## Index 521-660 Light Pole Pedestal – Bridge

### COMMENTS AND RESPONSES

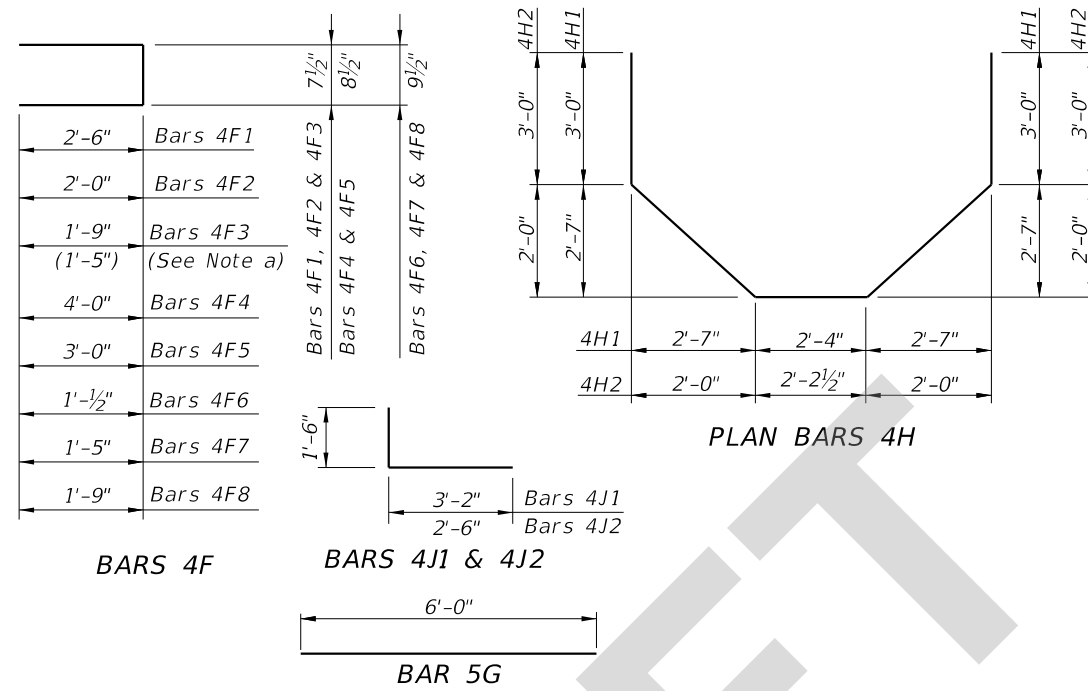
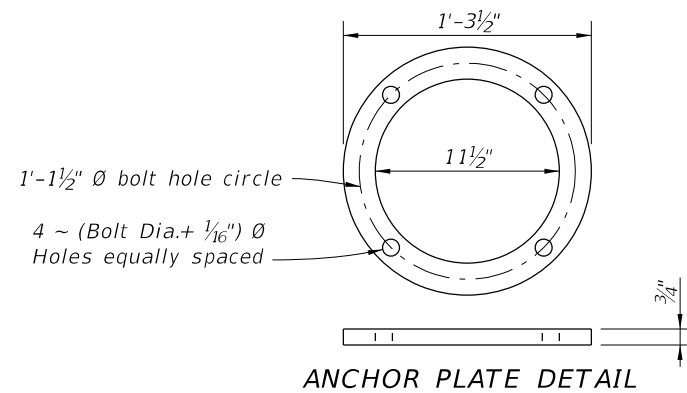
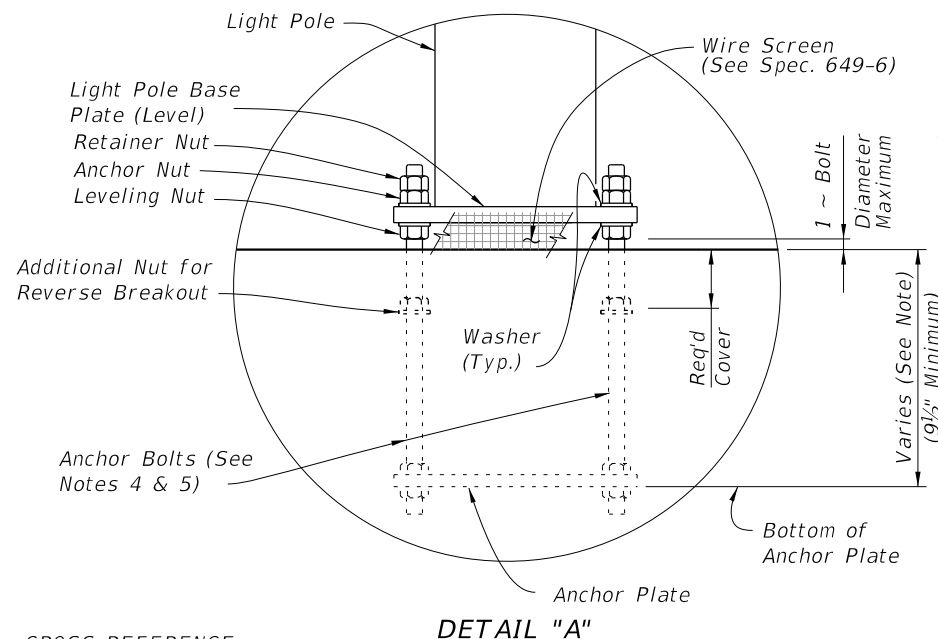
**COMMENT:** Will additional anchor bolt information similar to the previous Table 1 information be developed for the revised Index 521-660? If not there will be many bridge applications without a typical anchor bolt detail resulting in many different anchor bolt details being developed by different EOR's.

**COMMENT:** The old table that was removed had arm lengths shown, but the new note does not mention arm lengths. Can an arm length now be used?

**RESPONSE:** Note 4 indicates the diameter of the anchor bolt. I will add information to that note about the depth. The depth is a min. 9.5" but may longer as necessary depending on the option used in order to not conflict with rebar. Must maintain bottom cover.

**CHANGE MADE TO INDEX:** Sheet 4 will be updated to include a note about the depth of the anchor bolt.

**RESPONSE:** Good catch. We'll add some clarification for that.

**CHANGE MADE TO INDEX:** Sheet 4 Note 4 will be updated to clarify the arm length.
